Licence Holder Agnew Gold Mining Company Pty Ltd

Premises Agnew Gold Mine
LEINSTER WA 6437

Date of Amendment 8 September 2017

Amendment

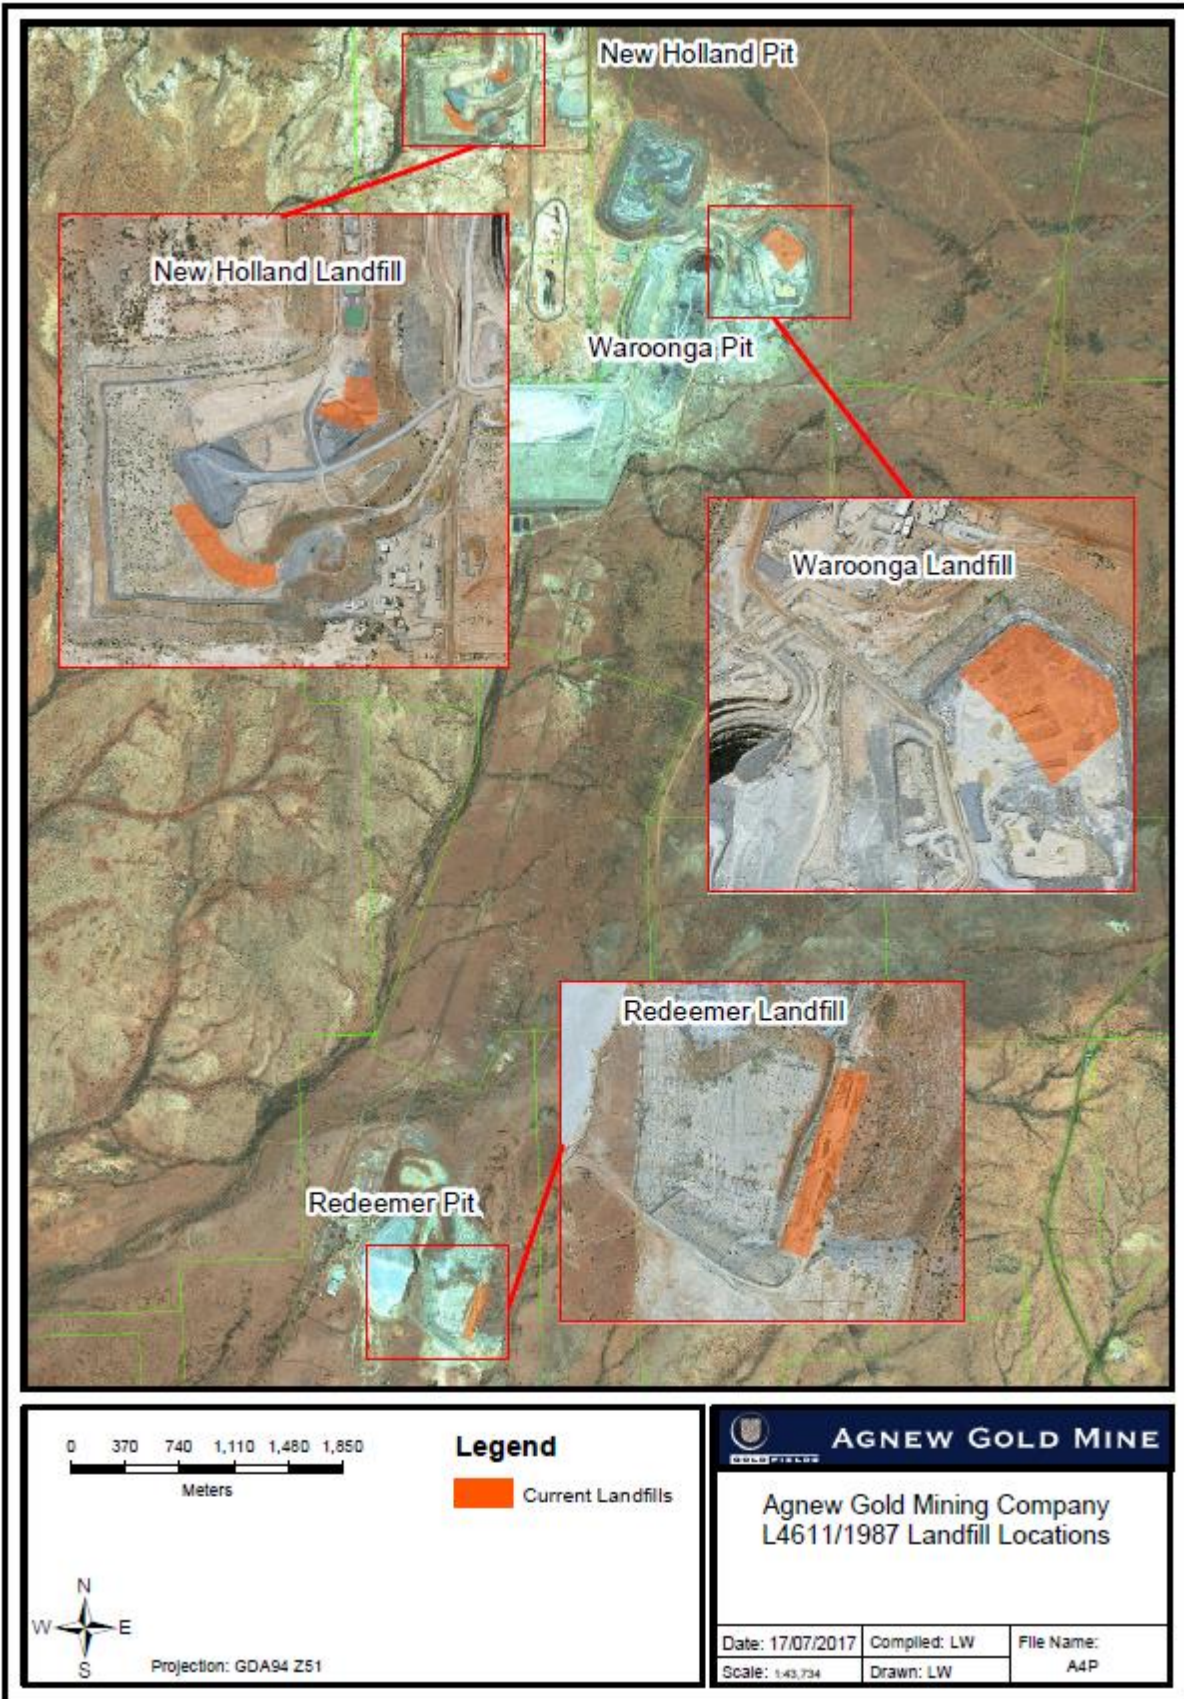
11. The Map of Landfill Locations in the Licence is deleted and replaced by the Map following:

Figure 3: Cross sections showing indicative seepage profile at year 1, 3 and 7 of tailings deposition into Songvang In-pit TSF – Section A (Golder 2016)

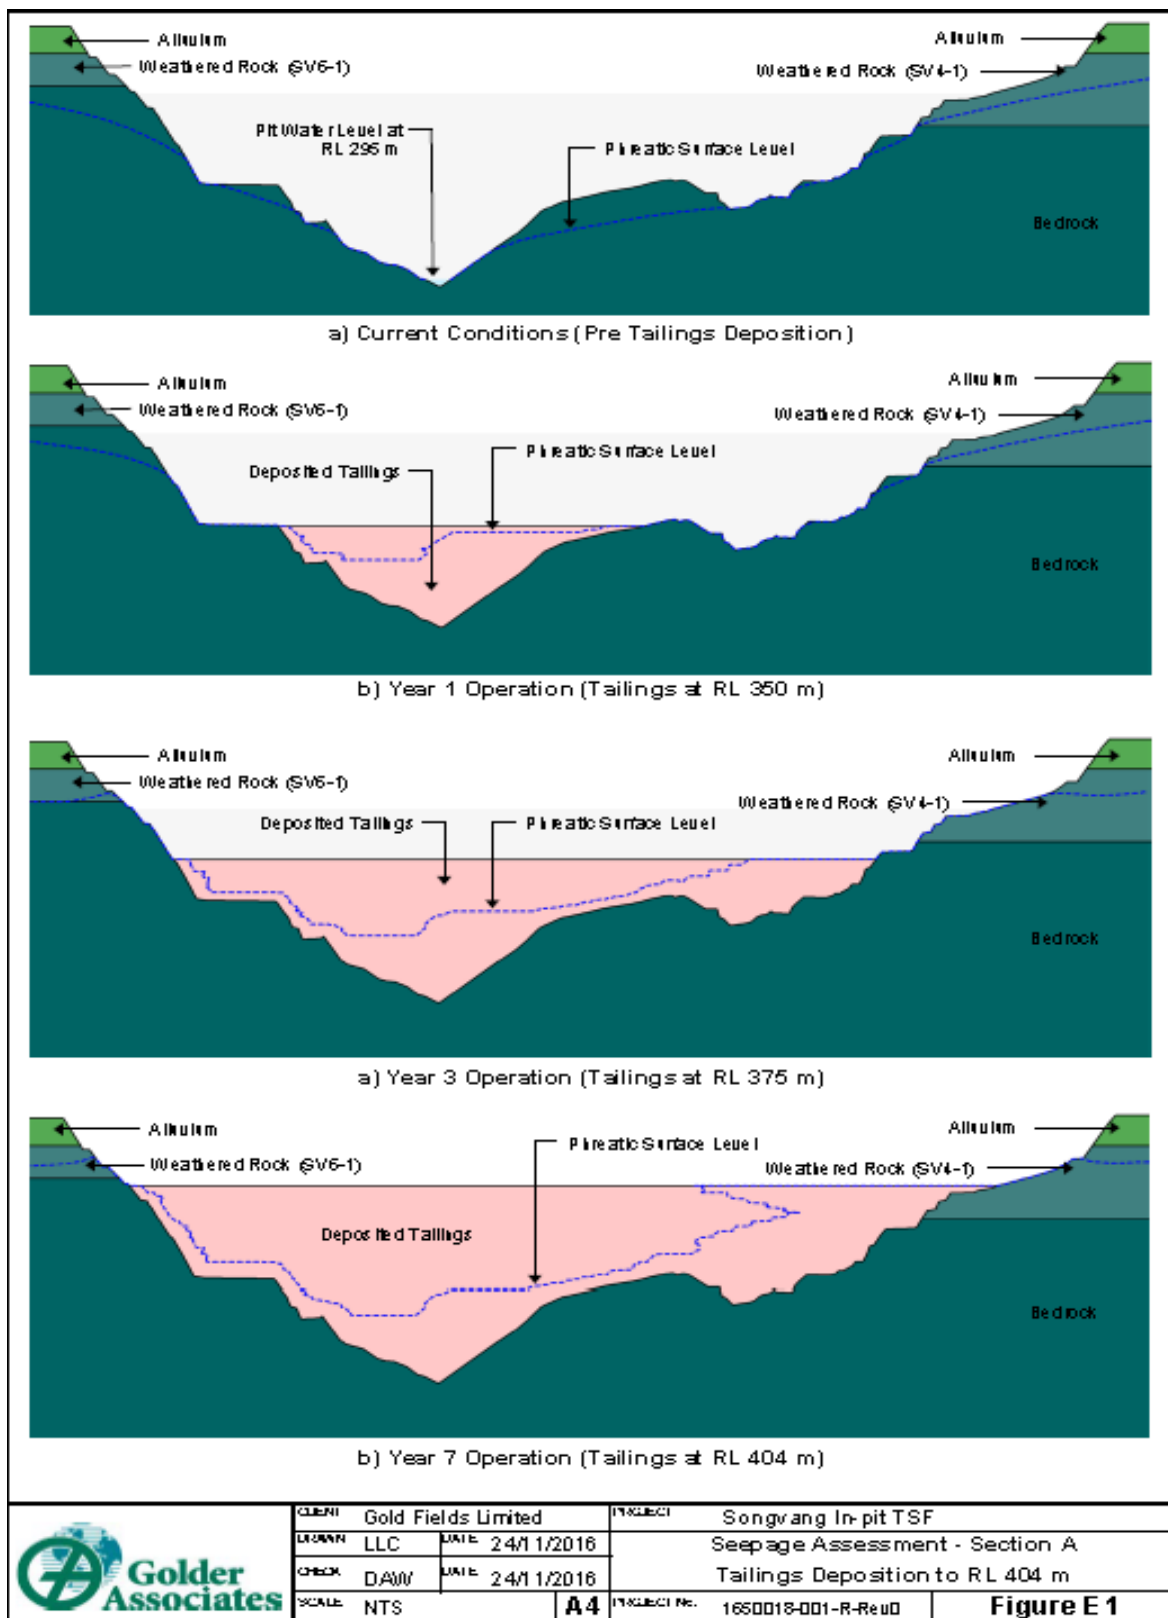
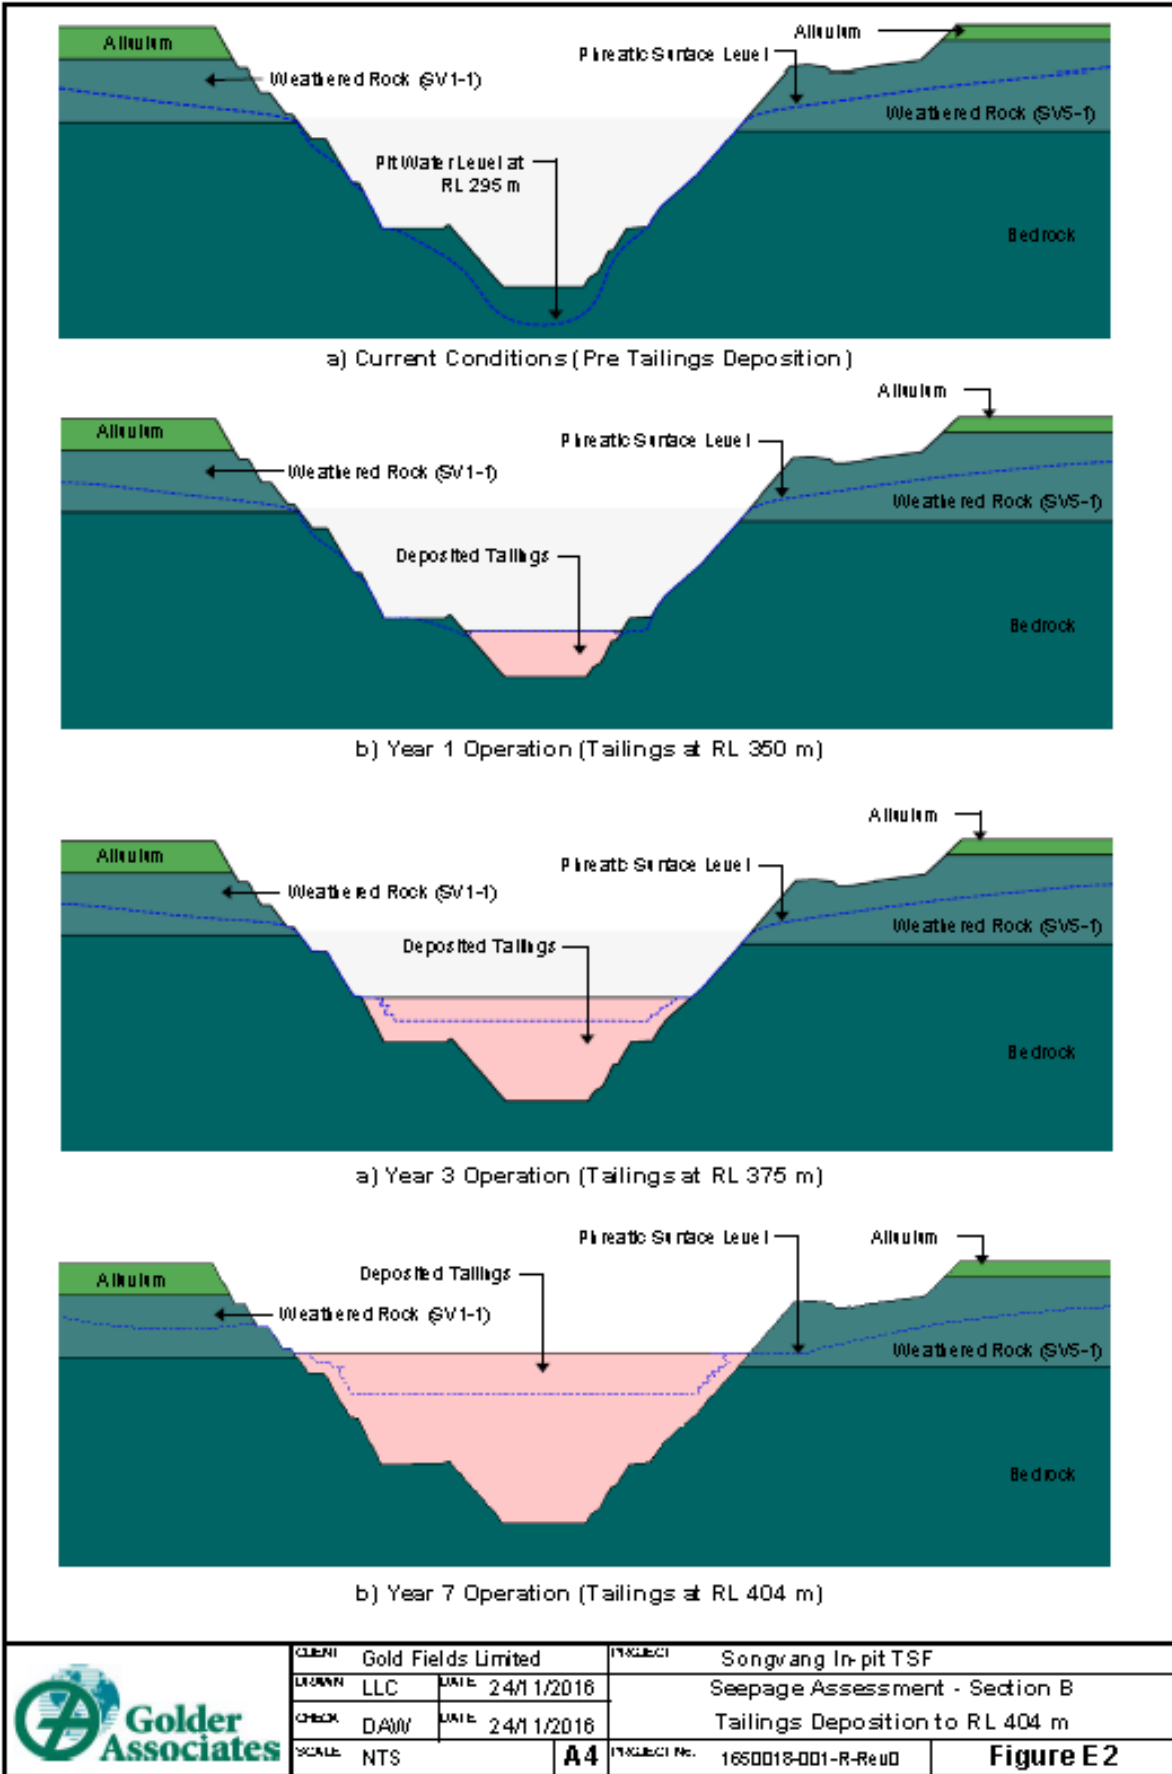
Waste: Tailings leachate and seepage	Groundwater: Local shallow aquifer is of low salinity (~1500 mg/L) (Golder 2017).	Land: infiltration through the base and internal walls of the TSF to groundwater.	Contamination of groundwater with potential impacts upon beneficial uses. Groundwater quality is acceptable for domestic and livestock use.	Slight	Rare	Low	The consequence is rated as "slight" with overall risk "low" because the pit will act as a groundwater sink during operations. The greatest risk of seepage is from the supernatant pond. The supernatant water level will be managed to be at least 1 metre below the lowest currently measured groundwater elevation (currently 407.5 RL) Local groundwater at the Songvang pit is contained within an aquifer at depths located between 14 mbgl to 30.5 mbgl (RL 425 m to RL 408.5 m respectively). Tailings deposition will be limited to 35 mbgl (RL 404 m). See Figures 3

Risk Event					Consequence rating	Likelihood rating	Risk	Reasoning	
Source/Activities	Potential emissions	Potential receptors	Potential pathway	Potential adverse impacts					
								<p>and 4 of Schedule 1 for indicative cross sections of tailings deposition (Golder 2017).</p> <p>The Licence Holder proposes monitoring six existing groundwater monitoring bores to confirm tailings deposition predictions by measuring groundwater quality and water table depth over time.</p> <p>Condition 1.2.1 will be amended to include Songvang In-pit TSF specifications plus tailings deposition limit of RL 404 m below the level of the aquifer. Also, condition 3.4.1 is to be amended to include parameters and frequency for the six existing monitoring bores around Songvang pit.</p> <p>Note: this Amendment Notice only addresses emissions and discharges associated with the operation of the In-pit TSF. Planning for TSF closure will be addressed through the mine closure planning process administered by the Department of Mines, Industry Regulation and Safety under the Mining Act 1978.</p>

Figure 5: General arrangement design for pipework at major creek crossings (Agnew 2017d)

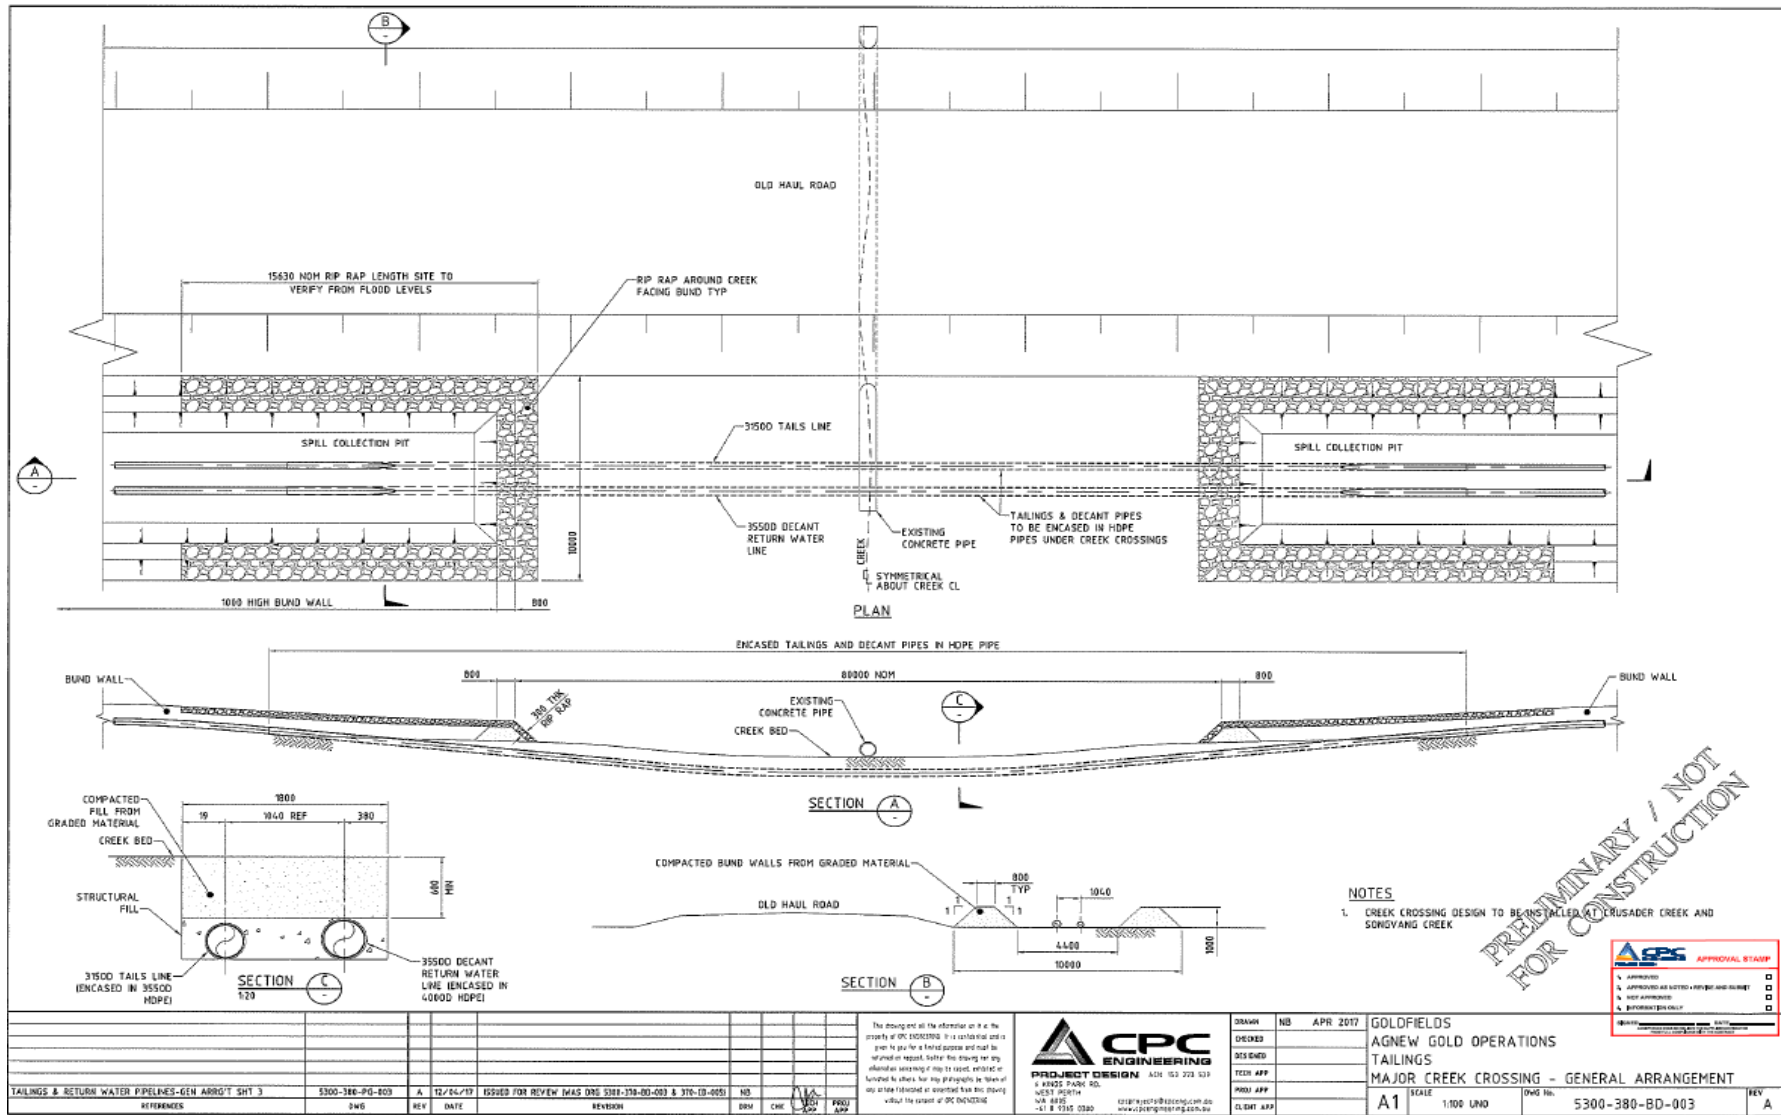
Risk Event					Consequence rating	Likelihood rating	Risk	Reasoning	
Source/Activities	Potential emissions	Potential receptors	Potential pathway	Potential adverse impacts					
		water)			metals/metalloids.			<p>The new pipeline routes will include under-creek crossings beneath Crusader and Songvang creeks. At the stream crossings the pipelines will be buried and also encased within an HDPE outer protective sleeve which will connect to spill collection pit on either side of the creeks. The under creek pipeline crossing infrastructure will be designed to withstand a 1 in 100 year's flood event. See Figure 5 in Schedule 1 for design of river crossings.</p> <p>A licence condition will be added that requires the under creek crossing to be constructed as proposed.</p>	
Category 5 Processing or beneficiation of metallic or non-metallic ore	Overtopping of Songvang In-pit TSF	Waste: Uncontrolled release of tailings/decant water	Terrestrial ecosystems: local soils, vegetation and surface water	Land: Direct discharge from overtopping of In-pit TSF	Contamination of surrounding soils with metals and metalloids, affecting soil and vegetation	Slight	Rare	Low	<p>The consequence is rated as "slight" with overall risk rated as "low"; tailings disposal will be limited to a final height of 35 mbgl during operations therefore overtopping occurring is not considered a credible risk.</p> <p>In addition, the Licence holder has committed to construct new bunds around the Songvang pit and the new process pond. All overflows within the bund will be directed towards the Songvang pit. These controls further reduce the risk.</p> <p>Applicant controls will be conditioned. No further controls</p>

Column 1	Column 2	Column 3
Infrastructure/ Equipment	Requirements (design and construction)	Site plan reference
Songvang In-pit TSF Process pond	<ul style="list-style-type: none"> Lined with a composite geosynthetic liner (double HDPE geomembrane with embedded drainage system to detect leakage) 5 m wide emergency spillway with a bunded drain directing any spillage back to Songvang In-pit TSF. 	Location shown in Figure 2 and indicative layout shown in Figure 6 of Schedule 1.
Tailings and decant return pipelines	<ul style="list-style-type: none"> Flow meters installed with pressure sensors along the pipeline; Isolation valves installed at discharge pumps and return water pumps; Telemetry system for monitoring flow; Pipelines will be bunded with the exception of sections of pipeline crossing the creeks; All pipelines crossing the creeks shall be installed below the bed of the creeks, and contained within another HDPE pipe. 	Route as shown in Figure 1 of Schedule 1. Plan reference 5300-370-001_B to 006_B. Pipeline crossings as shown in Figure 5 of Schedule 1.

Figure 7: Location of groundwater monitoring bores (shown in red outline) surrounding Songvang In-Pit TSF. (Solid red dots indicate decommissioned production bores) (Golder 2016)

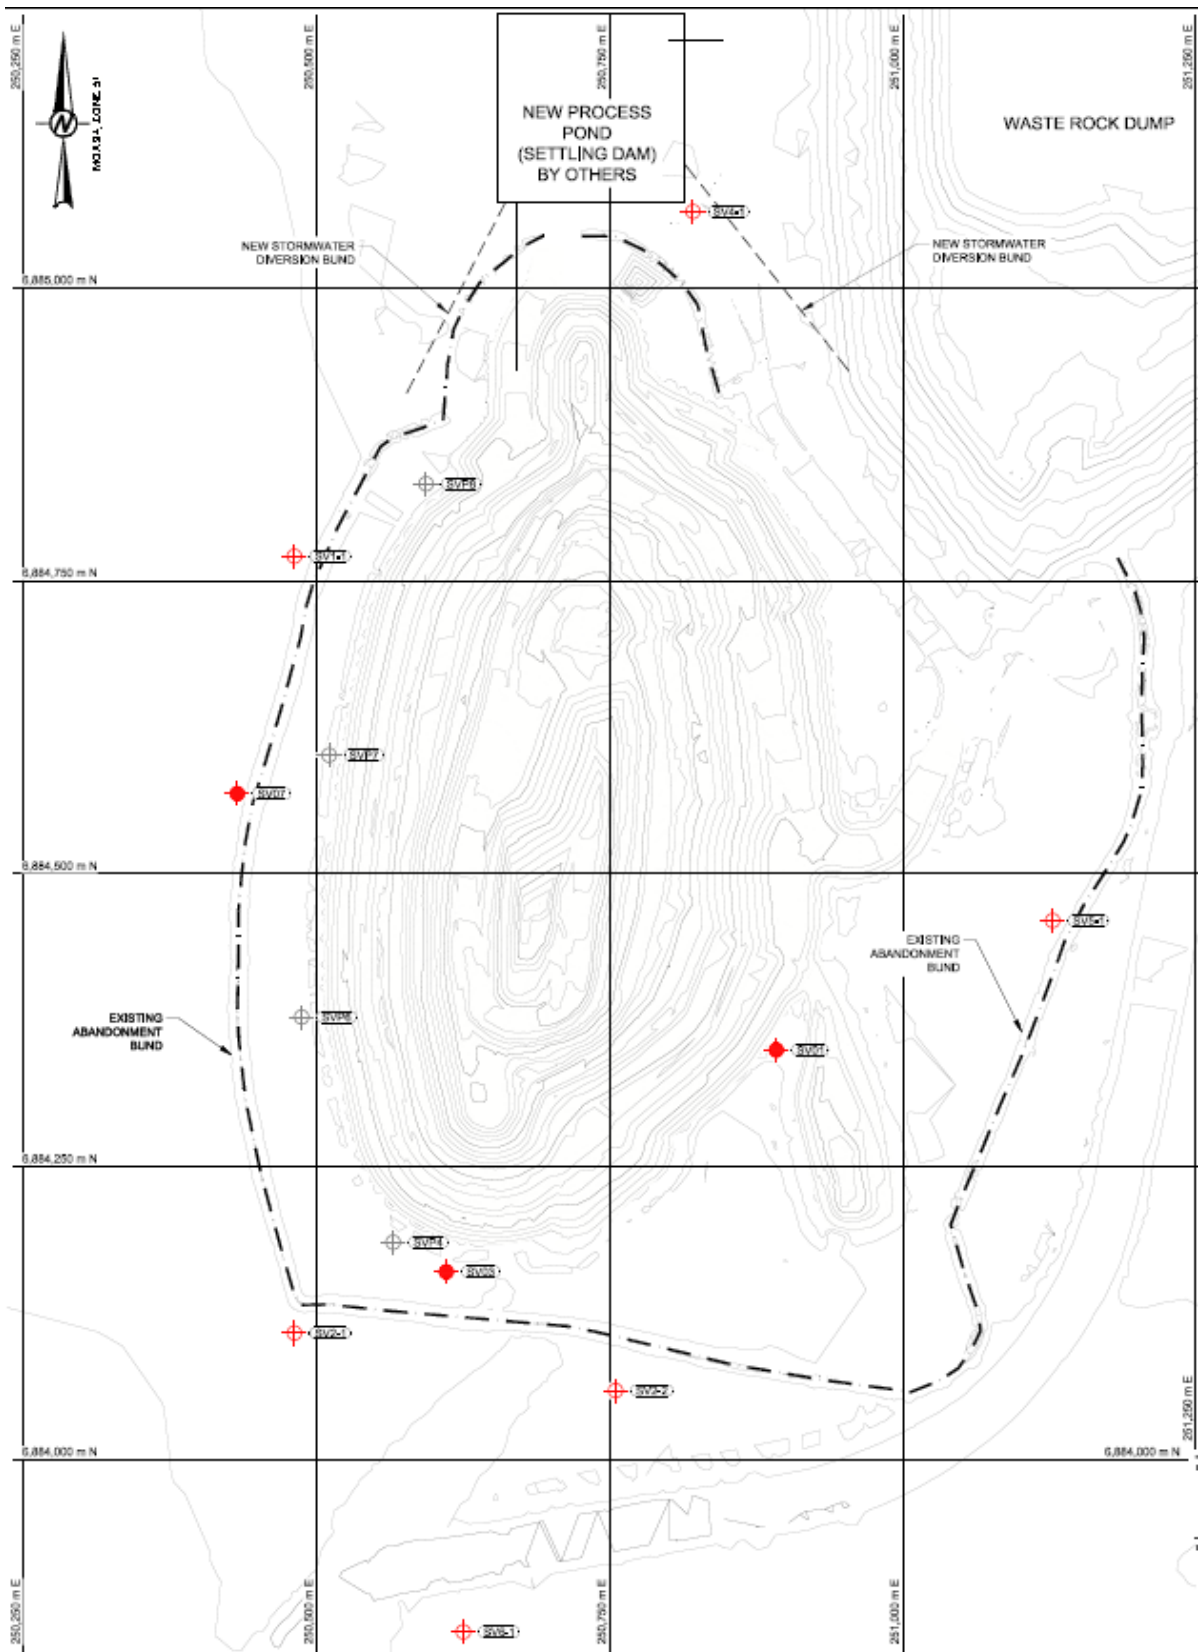
Songvang groundwater monitoring bores	Maintenance on six monitoring bores as necessary.	As shown in Figure 7 of Schedule 1.
Cyanide detoxification unit (including pipework to tailings hopper)	Not specified (storage facilities authorised under the <i>Dangerous Goods Act 2004</i>)	N/A
